Wellington CBD to Miramar / Seatoun Route 2 Bus Infrastructure Improvements

Concept Stage Safe System Audit

Prepared for:
Wellington City Council

28 August 2025

Figure 5-3: Relocated Bus Stop 7214 proposed design. INSET: Existing footpath width – view west.

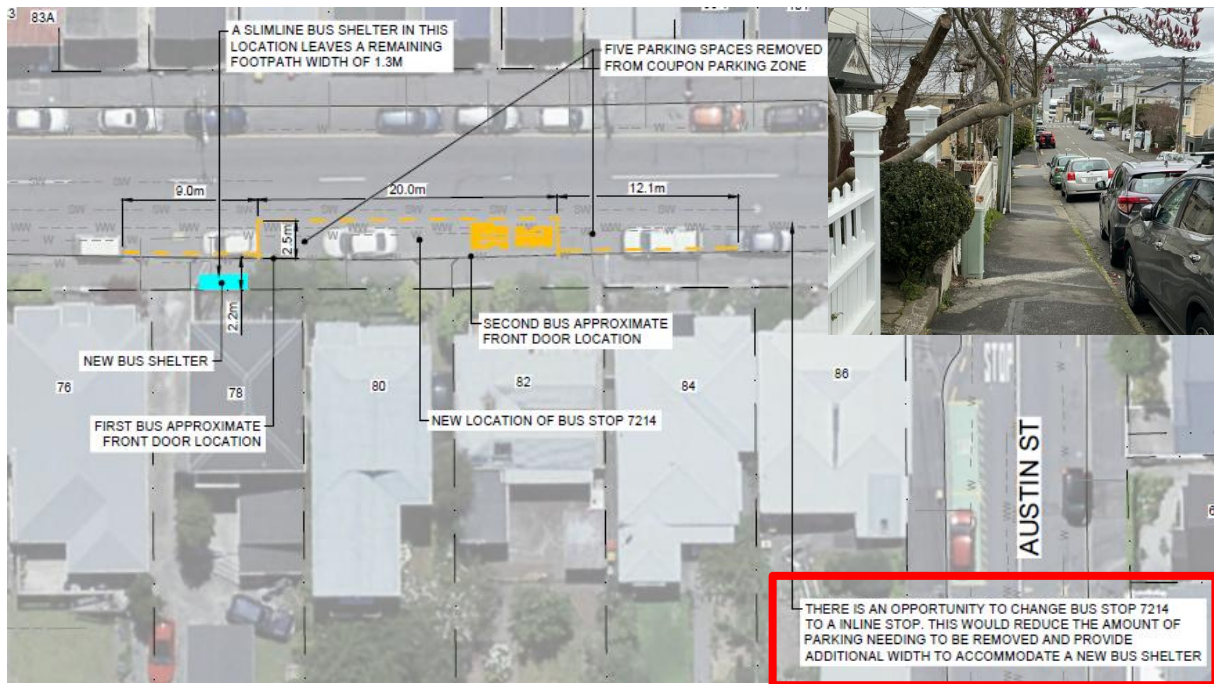
The proposed provision of a slimline bus shelter outside #78 Pirie Street at the new location for Bus Stop 7214 results in the available remaining footpath width being 1.3m as noted by the designers. This creates issues for mobility impaired pedestrians negotiating their way past the shelter on the footpath.

It is the view of the SSAT that an inline bus stop should be considered for Bus Stop 7214. This would provide additional width to provide a new bus shelter whilst minimising the width restrictions to the adjacent footpath.

1. Change the relocated bus stop 7214 to an inline bus stop so that the new bus shelter can be accommodated clear of the existing footpath.

Design team response	We agree with the SSAT’s finding and recommendation. An alternative option would be to retain this stop in its existing position, where a building canopy provides shelter for waiting passengers without reducing the footpath width.
Client safety engineer comment	Consider both options and provide a recommendation.
Client decision	Due to budget constraints, bus route efficiency, and a change in level of service, the design should retain existing bus stops.

Action taken	For the Traffic Resolution and consultation, designs show existing bus stops retained.
--------------	--

Figure 5-4: View of Bus Stop 6221 on Hamilton Road approach to SH1 (Wellington Road)

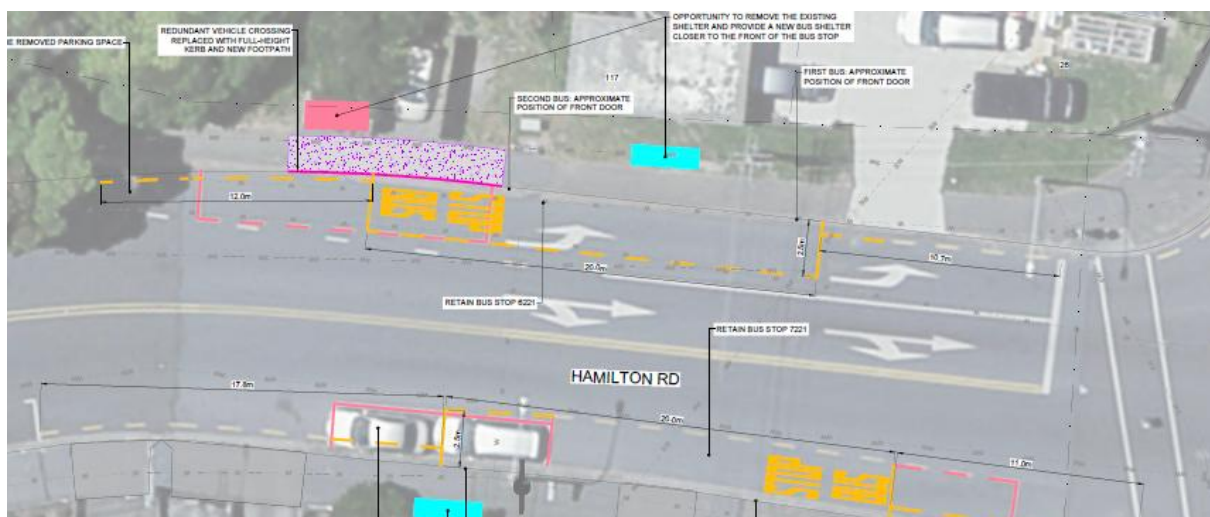
The existing bus stop (No 6221) located on the Hamilton Road approach to the intersection with SH1 (Wellington Road) and Kilbirnie Crescent is proposed to be lengthened and shifted closer to the traffic signals. The available space from the limit lines at the signalised intersection and the front of the bus stop is shown as 10.7m on the plans provided (refer to Figure 5-4 below).

The existing lane configuration will require the bus to move across into the straight ahead and turn right lane in order to proceed across the signalised intersection to continue their route towards Kilbirnie. This movement will result in the bus driver straddling both lanes due to the limited available space and increase the likelihood of the bus blocking both lanes and the associated traffic behind. When combined with the potential for the bus being held behind a motorist waiting to turn right at the intersection, there is an increased risk of traffic movements on this approach being delayed beyond a single phase.

The SSAT consider that the designers should review the lane configuration on this approach to the intersection with a view to altering the left lane to accommodate straight ahead and left turn movements, leaving the right lane for right turn movements only. This would have the advantage of the bus driver being able to proceed straight ahead from the bus stop into the (now) straight ahead / left turn lane in order to continue south on Kilbirnie Crescent towards Kilbirnie.

The new lane arrow markings should also be provided on the approach to the bus stop to ensure approaching motorists are aware of the lane configuration when a bus is at the bus stop.

Design team response	<p>1. We agree with the SSAT's finding and agree that altering the lane configuration as they've proposed is a potential option. However, before confirming a change to the lane configuration, we recommend undertaking an investigation of the turning movements at the intersection to assess how a change to the lane configuration would impact vehicle delays.</p> <p>2. We agree with the SSAT.</p>
Client safety engineer comment	Agre with Designer's responses.
Client decision	Agree with responses and comments. An investigation and review of the impacts will be undertaken within this project.
Action taken	Do not make any changes to the lane allocation as shown in TR drawings. Alternative solutions to this stop to be proposed in next stage of design.

Figure 5-6: Swept path of longer articulated “bendy” bus left turn into Onepu Road from Coutts St showing overrun of existing kerb and adjacent utility poles (power and traffic signal).
INSET: View of south-east corner of intersection with traffic signal poles and power pole.

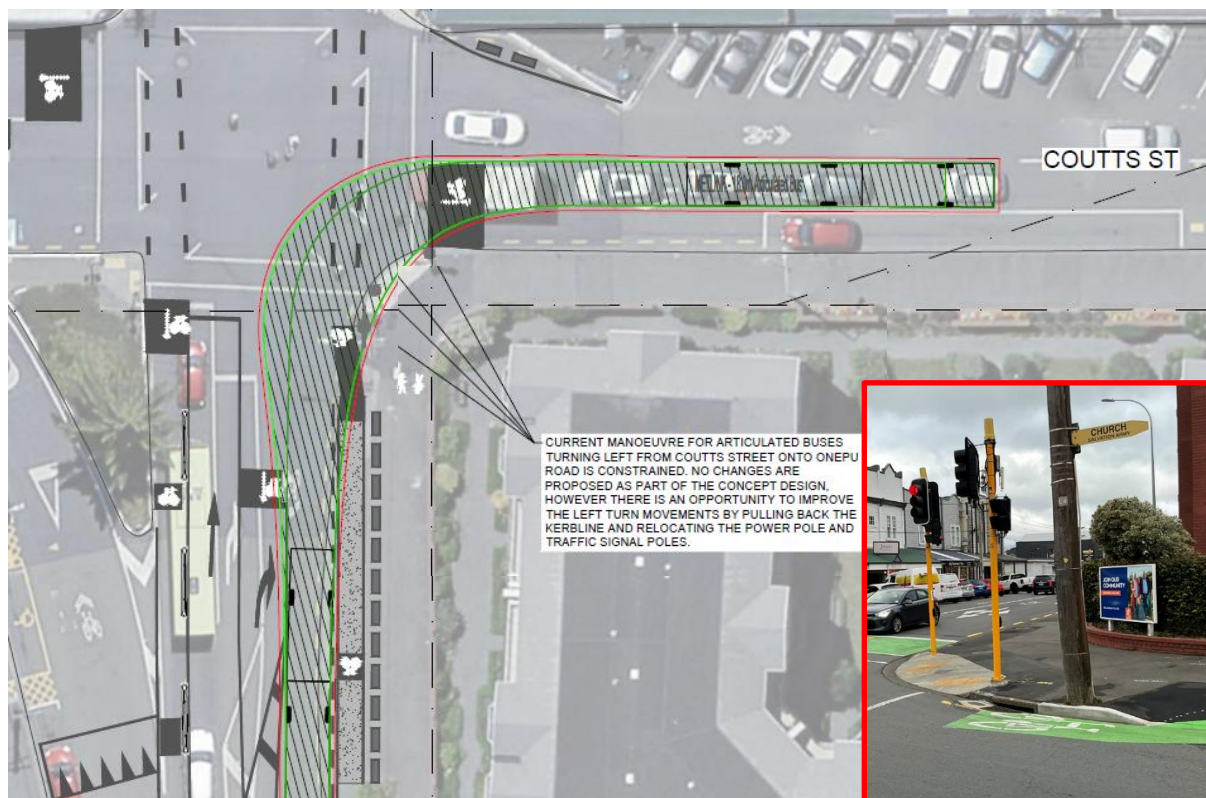
The south-east corner of the Coutts Street / Onepu Road intersection is proposed to accommodate longer articulated “bendy” buses turning left to access the Kilbirnie Bus Depot. As shown in Figure 5-6 below, the bus will not be able to undertake this manoeuvre without crossing over the existing kerbline. This would result in the bus colliding with the existing power pole and the traffic signal poles located on this corner of the intersection, as well as the potential to collide with any pedestrians waiting to cross the road at this location. As there is a retirement village located on this corner, the likelihood of the pedestrians being elderly and with less mobility is high and thus less able to readily move clear of a bus mounting the kerb.

It is noted that this issue has been identified by the designers as per the note on the drawing.

Design team response	We agree with the SSAT’s finding and recommendation to relocate the power pole and traffic signal poles. Another option that has been considered is to pull back the limit lines on the southern leg of Onepu Road. However, we note that the existing limit line for the right turn bay is already located significantly far back from the intersection (approximately 13m) and space to the south is constrained to be able to provide sufficient stacking length. An alternative option could be to combine the
----------------------	--

through and right turn lanes into one shared lane, noting that an assessment should be done to confirm the impact on vehicle delays.
Client safety engineer comment	Further assessment and a recommendation required.
Client decision	Agree with responses and comments. An investigation and review of the impacts will be undertaken. Review design of limit line being pulled back.
Action taken	WCC to instruct design engineer to investigate impacts on vehicle delays, and tracking.

Figure 5-7: Proposed road markings / intersection adjustments at Miramar Avenue / Park Road.
INSET: Example of raised apron at roundabout in Tawa with mountable kerb.

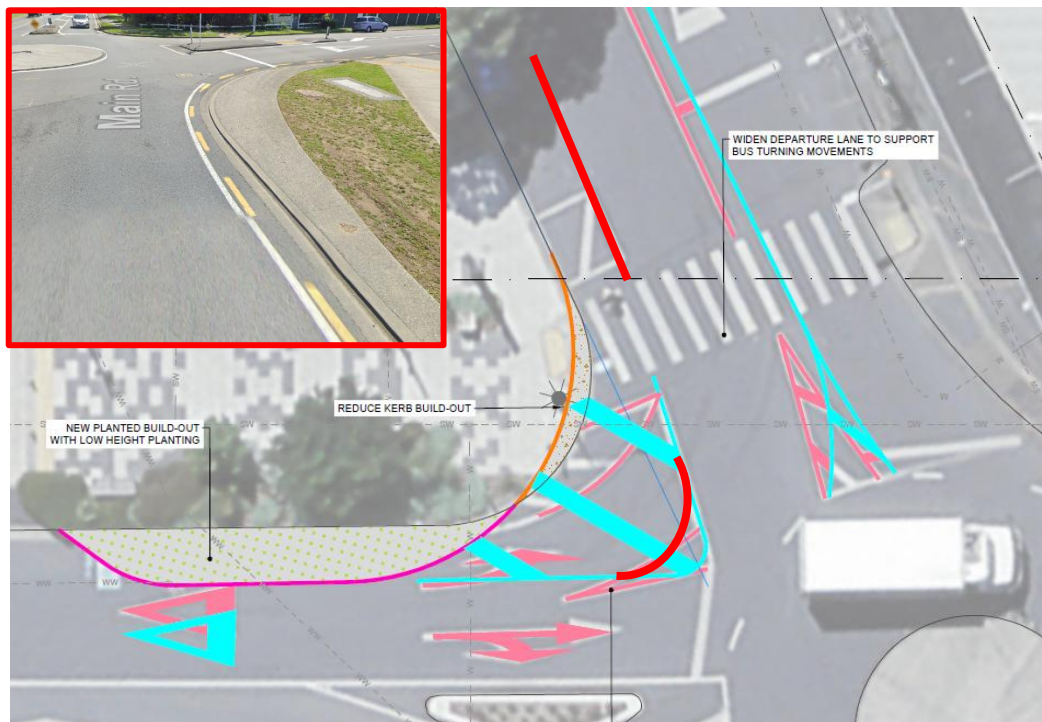
The proposed adjustments for the left turn movement from Miramar Avenue into Park Road are shown in Figure 5-7 below. It is noted that the left turn movement is such that left turning vehicles will have no option but to track across the proposed hatched road markings. Additionally, there is no edgeline guidance for motorists beyond the existing pedestrian crossing, to ensure that they are guided past the parked vehicle space to the north.

Furthermore, by providing such a large left flush island there is a risk of light vehicle drivers deciding to shortcut the roundabout by tracking over the flush island. In turn creating an acute angle towards the western side of the zebra crossing, resulting in an increased risk of drivers looking right (towards the roundabout) and not seeing a pedestrian on the pedestrian zebra crossing until they are upon it. The provision of a mountable kerbside island under the flush road markings should be considered. This will force the majority of left turning drivers to proceed to the roundabout and after navigating that intersection orient their vehicles perpendicular to the pedestrian zebra crossing, thus providing improved sight lines towards any pedestrians crossing from the western side. Larger vehicles, such as buses will be able to track over the mountable island to accommodate their vehicle swept path.

1. Alter the extent of the proposed road markings so that a 95th percentile vehicle can safely carry out a left turn manoeuvre into Park Road without crossing into the hatched shoulder area; and
2. Provide a mountable apron with mountable kerb for the left turn movement into Park Road.
3. Add an edgeline to the north of the existing pedestrian crossing to guide motorists past the parking spaces to the north (refer to red line on Figure 5-7).

Design team response	<p>1. We agree with the SSAT’s recommendation to alter the hatched shoulder marking. The shoulder design will be finalised during detailed design based on tracking envelopes for left-turning vehicles.</p> <p>2. We agree with the SSAT’s recommendation to provide a mountable apron. We do note that consideration will need to be given to ensuring that there is clear separation between the apron and the footpath to ensure that there is a clear separation between the road and the pedestrians space.</p> <p>3. We agree with the SSAT’s recommendation to add an edgeline on Park Road. We recommend that, in addition to the edgeline, hatched shoulder markings are included so it is clear that this is not a separate traffic lane.</p>
Client safety engineer comment	Agree with Designer’s responses.
Client decision	Agree with responses and comments. Complete shoulder marking, include a mountable apron, add edgeline, and include hatched shoulder marking in detailed design.

Action taken	WCC to direct engineer to complete shoulder marking, include a mountable apron, add edgeline, and include hatched shoulder marking in detailed design.

Figure 5-8: View of existing bus stop 6232 on Hobart St with non-cycle friendly grate (see INSET).

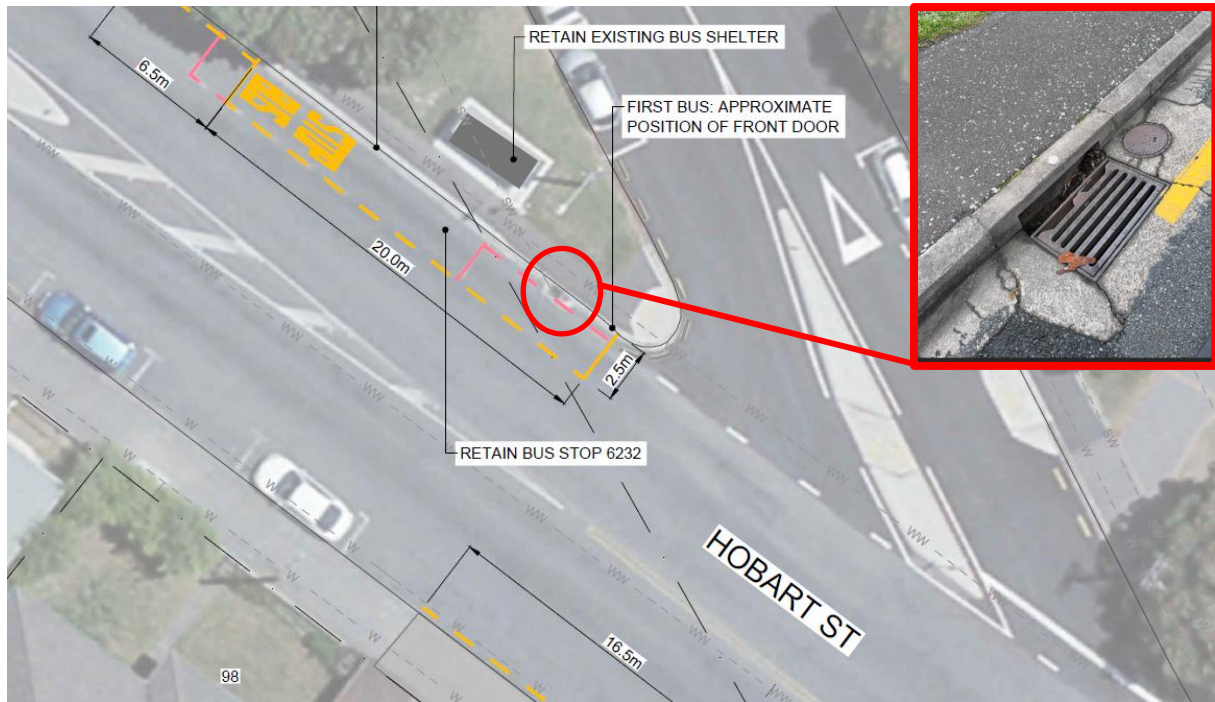
There is a non-cycle friendly grate in the bus stop at this location (refer to Figure 5-8). The drawing notes that this area is subject to proposed transitional cycleway changes. Consideration should be

given to changing the drainage grate to a cycle friendly grate in advance of the proposed transitional cycleway changes.

1. Replace the existing drainage grate with a cycle friendly grate.

Design team response	This item is out of scope of the Route 2 Bus Infrastructure improvements project. However, we do agree with the SSAT finding and recommend that replacement of this grate is added to WCC's schedule of maintenance works.
Client safety engineer comment	Agree with Designer's response.
Client decision	Agree with responses and comments. Replace existing grate with cycle friendly grate.

Action taken	Direct designers to replace existing with a cycle friendly grate in the design drawings.
--------------	--

Figure 5-9: Proposed priority changes at Devonshire / Caledonia / Hobart intersection.

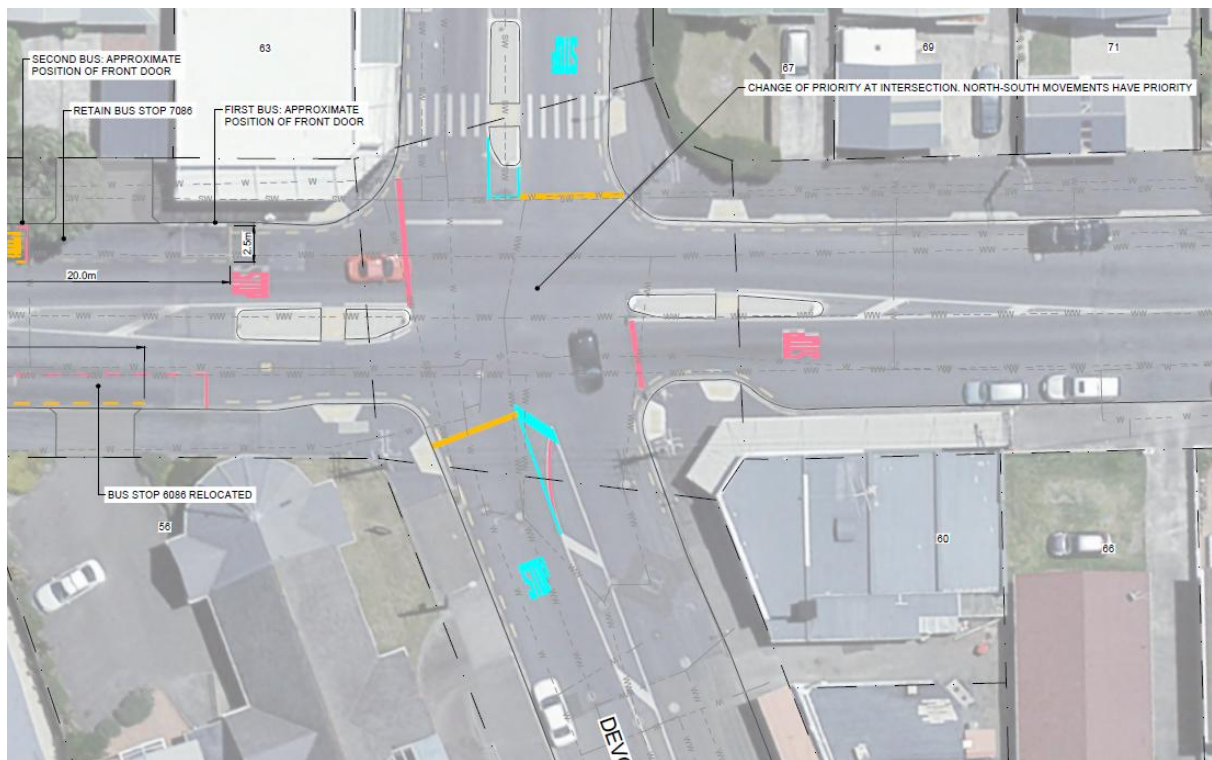
The intersection of Devonshire / Caledonia / Hobart is proposed to be altered so that Hobart Street has priority (refer to Figure 5-9 below). The drawings indicate a change in the road markings but do not indicate any proposed changes to the signage on each approach.

The existing gated STOP signs present on the respective Hobart Street approaches will need to be relocated to the Devonshire Road and Caledonia Street approaches. It is noted that there is no central island on the Devonshire Road approach to accommodate a secondary STOP sign. Given that this is a change to an existing intersection, particularly care needs to be taken to ensure that it is clear to motorists on the approaches that previously had the right of way that they are now required to give way.

1. Ensure that the changes to the signage are incorporated into the design at the detailed design stage; and
2. Provide a central traffic island close to the limit line on the Devonshire Road approach to enable a secondary STOP sign to be accommodated on the right-hand side of this approach.

Design team response	<p>1. We agree with the SSAT’s recommendation. Signage has not been detailed at the concept design stage. The full extent of signage works will be shown at the detailed design stage. We would also recommend installing temporary “New Road Layout” signage at the intersection to warn drivers of the change in priority.</p> <p>2. We agree with the SSAT’s recommendation. Providing a median traffic island on Devonshire Road would also improve safety for pedestrians crossing Devonshire Road by provide a crossing refuge. The existing flush median is approximately 2.5m wide, which provides suitable width to install a refuge island.</p>
Client safety engineer comment	Agree with Designer’s responses.
Client decision	Agree with responses and comments. In the detailed design, provide signage detail and median traffic island on Devonshire Rd.
Action taken	Direct the designers to include in detailed design drawings, signage detail and median traffic island on Devonshire Rd.

Figure 5-10: Proposed changes to Hobart Street / Broadway intersection. INSET (top): Hobart St approach to Broadway, note the already removed bus stop. INSET (bottom): Existing power pole at location of relocated bus stop.

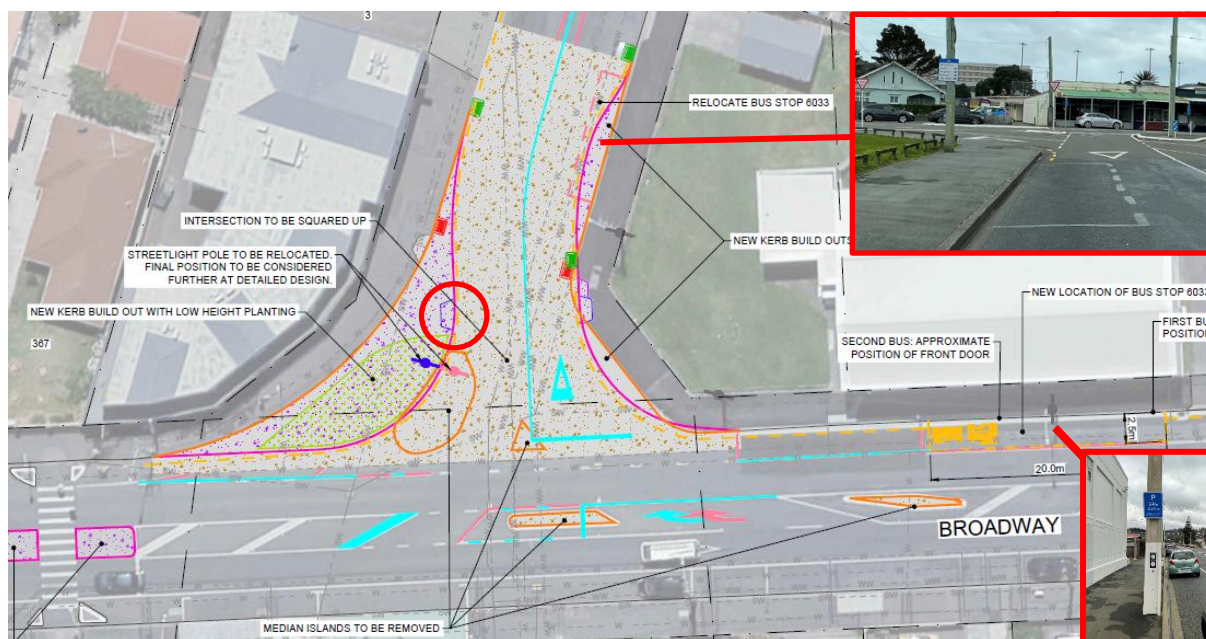
The realignment of the Hobart St approach will better define the intersection. As part of this realignment there is new kerb buildout on the western side of Hobart St which results in the western pedestrian drop kerb (cut down) being relocated on the new kerblines (refer to Figure 5-10 below). Visually impaired pedestrians will likely find it more difficult to locate the new pedestrian drop kerb (cut down). Consideration should be given to providing directional tactile pavers to guide pedestrians to the new pedestrian drop kerb (cut down).

It was noted on site that the outbound bus stop on Hobart Street at Broadway has already been relocated back to the original location (refer to INSET (top) in Figure 5-10 below) on Broadway. This temporary bus stop location on Hobart Street was only in place while construction work to the church was underway in 2022. The bus stop on Broadway will have a large power pole (refer to INSET (bottom) in Figure 5-10 below) located in the middle of the bus stop. As this bus stop is the closest one to the Wellington Airport (excluding the more expensive Airport Express (AX) Bus Route), there is likely to be bus passengers alighting with luggage. Designers to satisfy themselves that the rear door on a longer articulated “bendy” bus will not be blocked by the power pole and impacting the egress of bus passengers.

1. Provide directional tactile pavers to guide pedestrians to the new pedestrian drop kerb (cut down) on the western side of Hobart Street; and
2. Ensure that the rear door on a longer articulated “bendy” bus will not be blocked by the power pole and impacting the egress of bus passengers.

Design team response	<p>1. We agree with the SSAT’s recommendation. Tactile pavers have not been included as part of the concept designs; they will be included at the detailed design stage.</p> <p>2. The back door of an articulated bus is located 10.5m to 12.5m from the front of the bus. The pole is located approximately 9.5m from the front of the bus stop. If a bus is aligned properly with the front of the stop, the power pole will not obstruct any doors. However, there is a risk of conflict if a bus stops further forward than the front of the stop.</p>
----------------------	---

An alternative option considered was to align the front of the bus stop with the power pole. However, an articulated bus would not be able to track into the stop properly after turning left from Hobart Street.
Client safety engineer comment	Further work required at the design stage to identify the preferred solution.
Client decision	Agree with responses and comments. Provide directional tactiles, and further detail that the rear door of articulated bus will not be impacted by pole location.
Action taken	Designer has shown in the TR drawings that stop has been shifted to avoid conflict with pole. Direct designer to provide directional tactiles in detail design drawings.

Figure 5-11: Relocated inbound bus stop 7040 on Dundas Street prior to Falkirk Avenue. Note the power pole (circled in red) located midway along the bus stop.

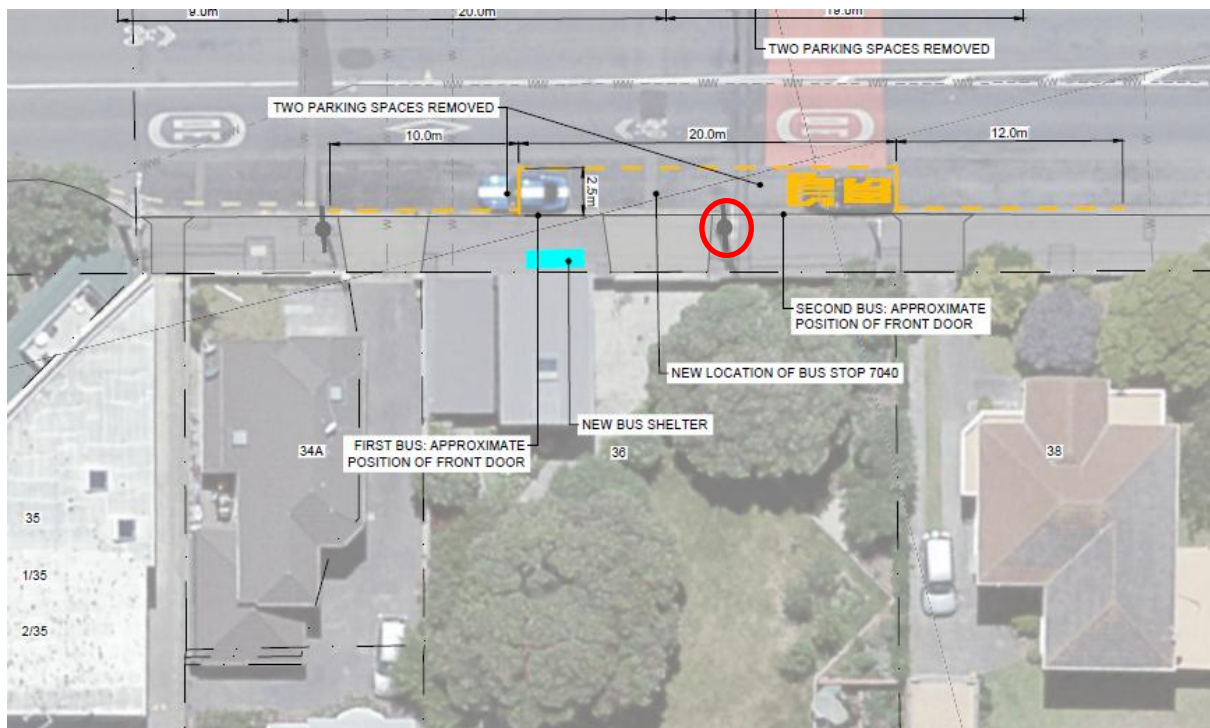
The relocated inbound bus stop 7040 located on the Dundas Street approach to Falkirk Avenue has been positioned such that there is an existing power pole present in the middle of the bus stop on the footpath. There is the potential for the rear door on a longer articulated “bendy” bus to be blocked by the presence of the power pole affecting the ability of passengers to exit the bus from the rear door.

It is likely that this bus stop is well utilised given its proximity to the local supermarket located on the south-east corner of the intersection.

Design team response	The back door of an articulated bus is located 10.5m to 12.5m from the front of the bus. The pole is located approximately 11m from the front of the proposed bus stop location. We recommend that the bus stop is moved east by approximately 1m, which can be accommodated without affecting the accessibility of the front door of the first or the second bus, and the front of the stop would still be located at the proposed bus shelter location.
Client safety engineer comment	Agree with Designer’s response and recommendation.
Client decision	Agree with responses and comments. Move bus stop east 1m.
Action taken	Direct designers to move bus stop east 1m in Traffic Resolution drawings.
